Addendum No. 1
November 30, 2022

Tri-Cities CIC: Chiller Replacement
Washington State University
Richland, WA

Project No. 1744-2022
Washington State University
Facilities Services, Capital

7 MECH ROOM PIPING ISO VIEW - DEMOLITION
 Scale: NOT TO SCALE

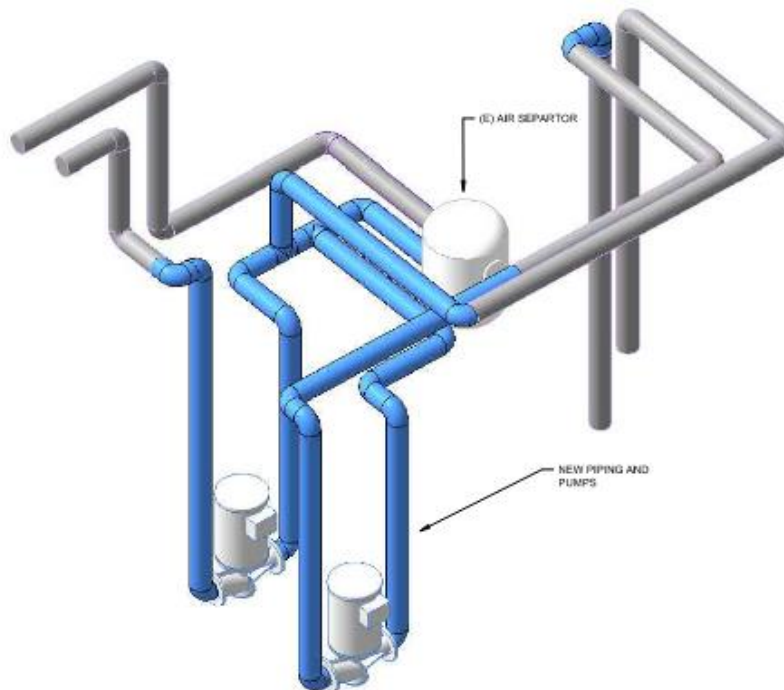
DWG 1-3. Sheet M502 – Mechanical Details

Item 1. REVISE M-502, Detail 7 and 8 as shown in attached detail drawing.
